Geotechnical Investigation

Proposed Residential Development

4386 Rideau Valley Drive
Ottawa, Ontario

Report PG5828-1 Revision 5 dated July 19, 2024

Figure 3 - Section A - Existing Conditions - Seismic Loading

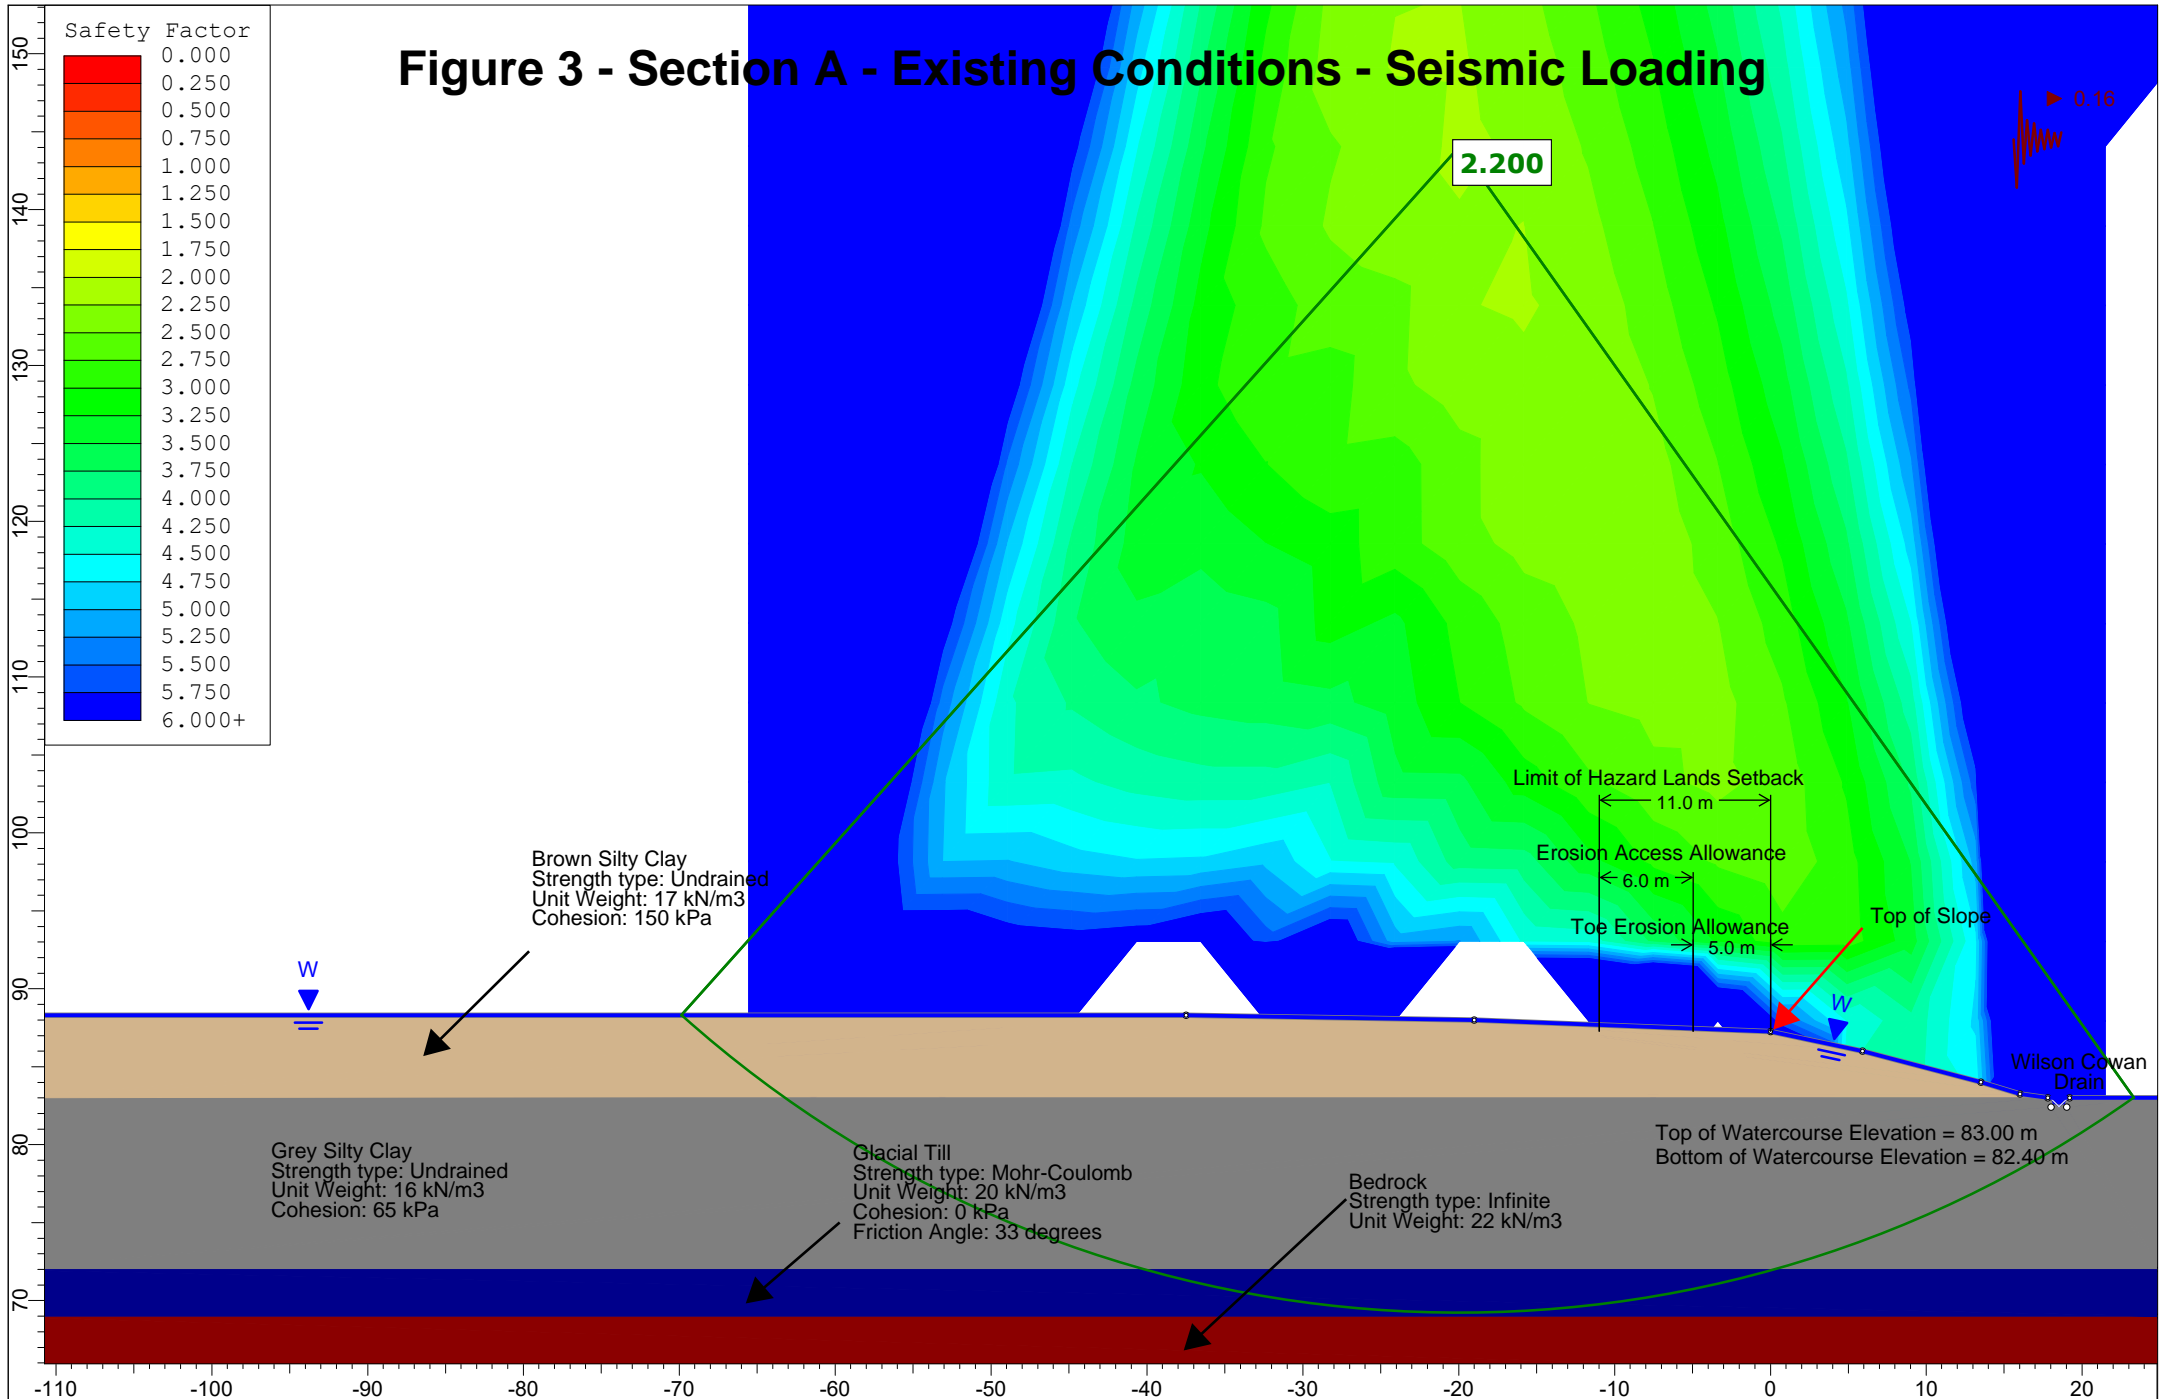
The soil annotations on Figure 3 appear to be floating.

(City02): Outstanding: *Referencing Figure 3, page 52 of 114, three soil types are indicated to be included in the slip circle. Also note that grey silty clay soils are a significantly weaker soil and not considered homogenous. The City will need to see a couple of non-circular failure surface calculations.*

Noted. The annotations for soil layers in Figure 3 have been modified in the above-mentioned revised report.

This comment has been acknowledged. Multiple non-circular failure surfaces have been added to Figure 3. Please refer to the above-mentioned revised report.

Figure 4 - Section B - Existing Conditions - Static Loading

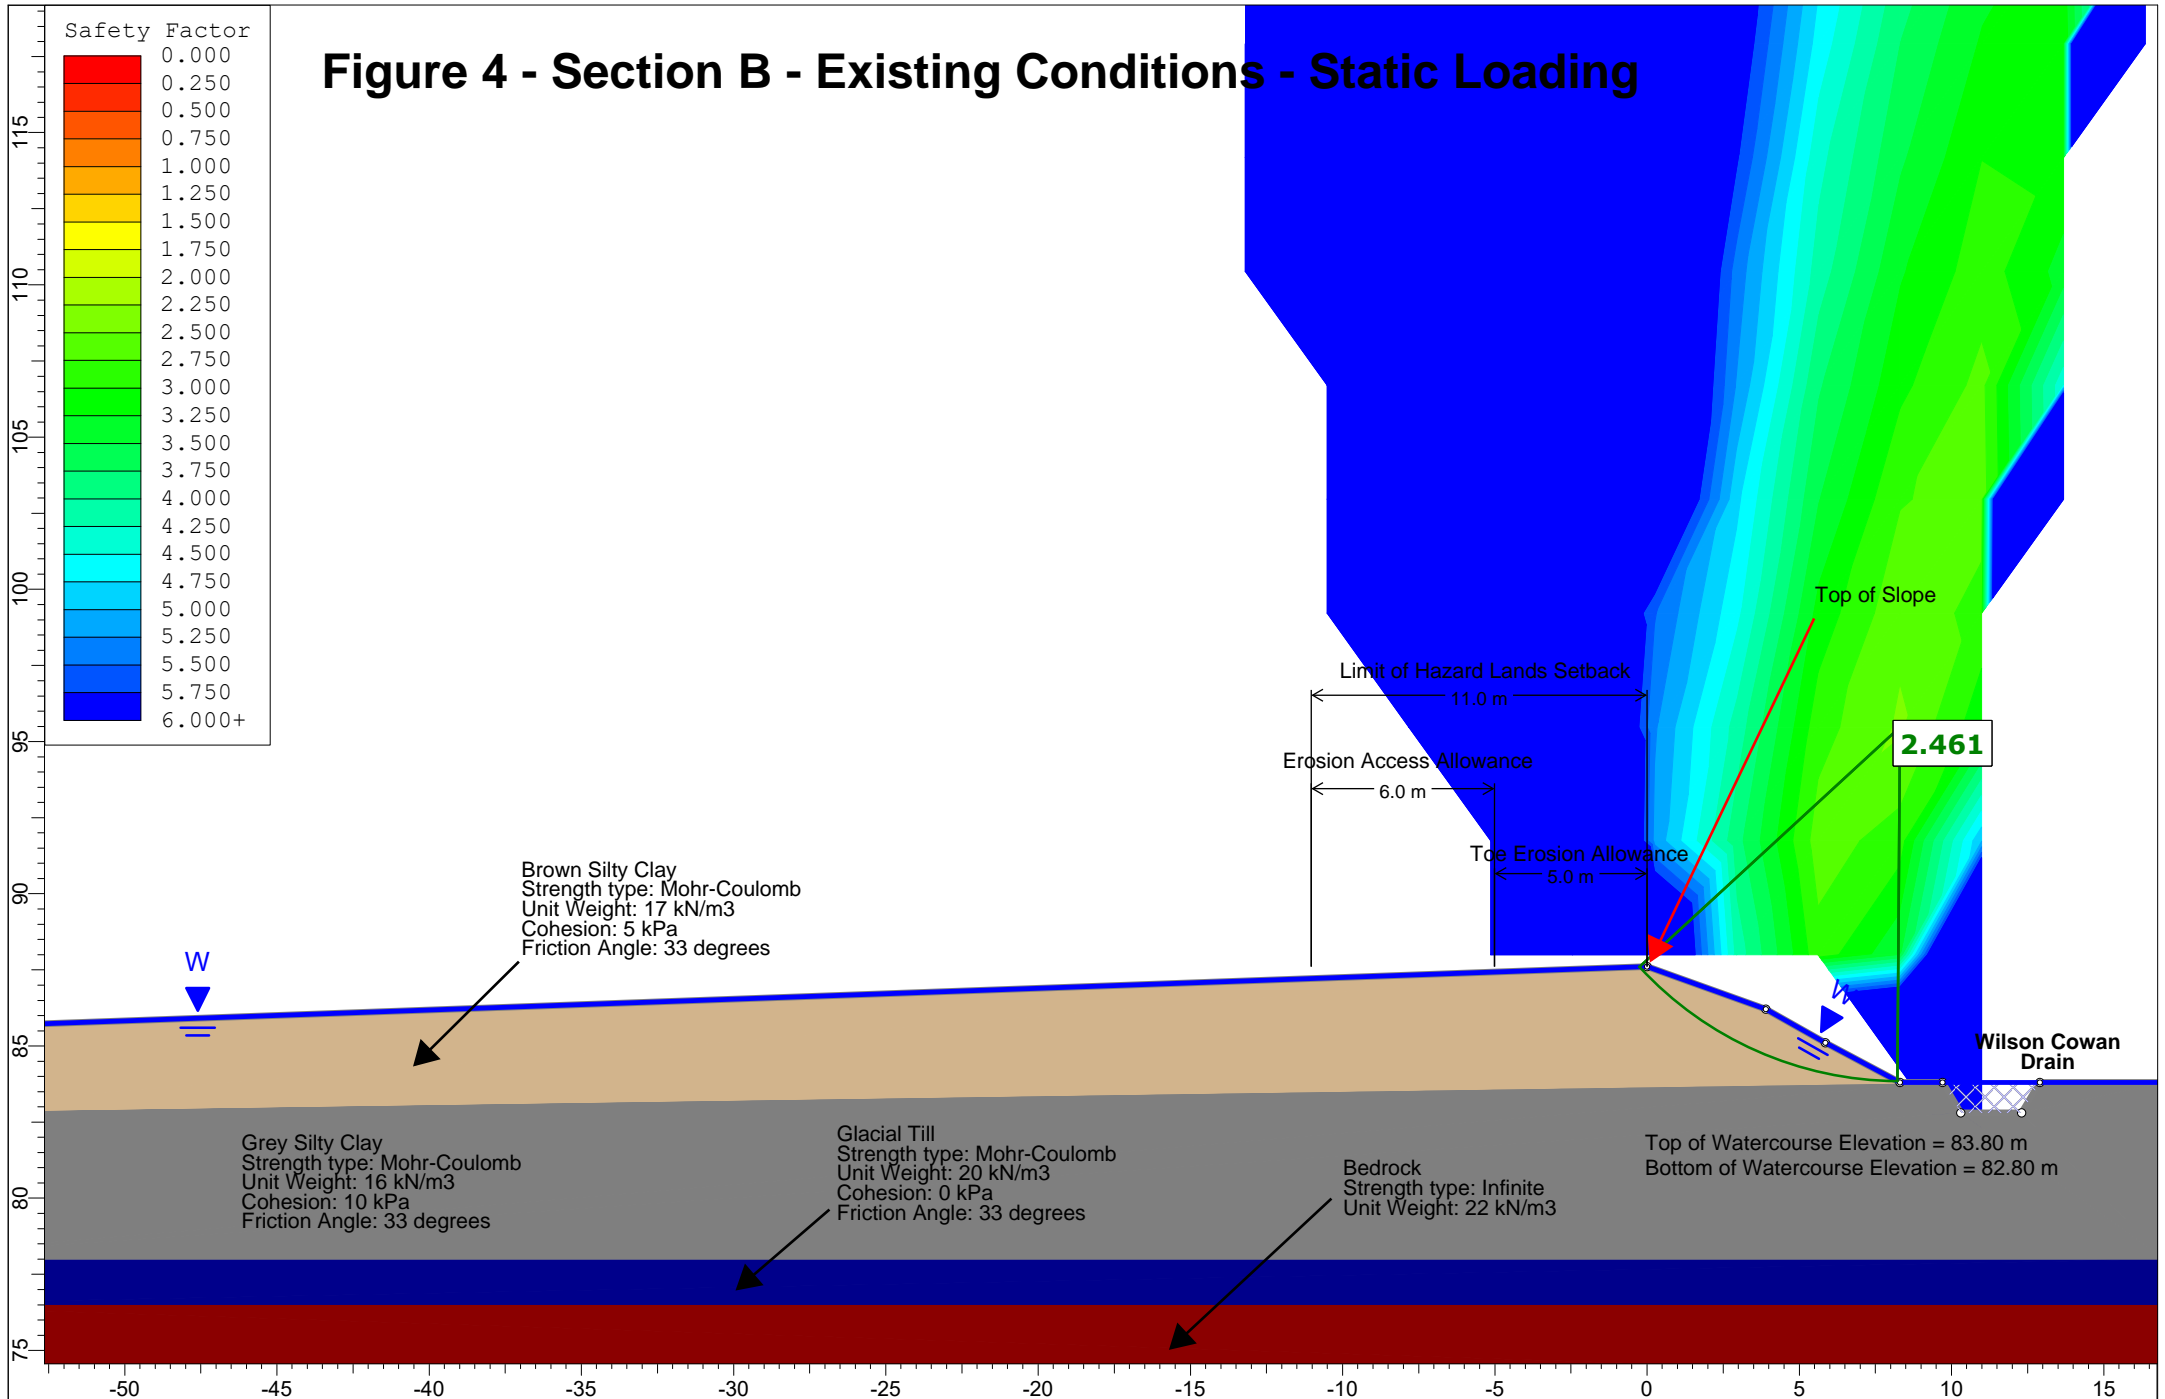
Please include bathymetric survey data used for Figure 4 (amongst others).

The bottom elevations of the watercourses at the studied cross sections has been determined using a high precision GPS, during our site visit to review the slope conditions. These elevations have been added to the slope cross sections included in the revised geotechnical report referenced above.

Figure 1. Criteria for evaluating liquefaction susceptibility of fine-grained soils (Bray et al. 2004).

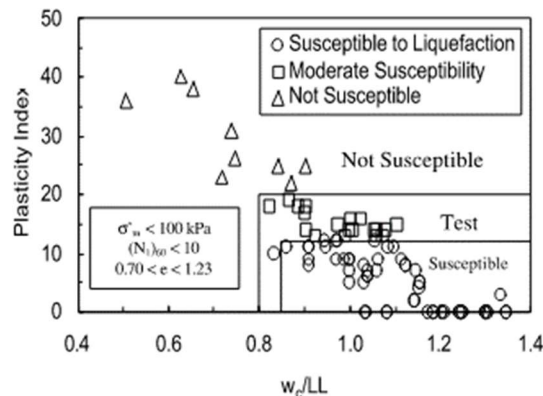
(City01): Comment 2.27 *The comments that the subject site are not susceptible to liquefaction requires an exhaustive discussion: whichever approach the consultant takes will require proof of similitude and full copies of papers provided to the City showing unequivocal support.*

(City02): Outstanding: *While the City understands the comparison implied here, we need to see testing or other data that confirms that this specific site meets these requirements.*

Paterson's Previous Response: The soils encountered at the subject site consist of silty clays, which are cohesive in nature. These soils were evaluated for liquefaction susceptibility in accordance with the criteria prepared by Bray et al. 2004 which determines that all soils with a plasticity index exceeding 20% are not liquifiable (Figure 1). In general, the plasticity index results completed on samples taken from the silty clay layer were found to be above 20. Therefore, the encountered soils are not susceptible to liquefaction. Reference should be made to subsection 5.4- Design for Earthquakes in the abovementioned revised geotechnical report, for further details on liquefaction susceptibility at the subject site.
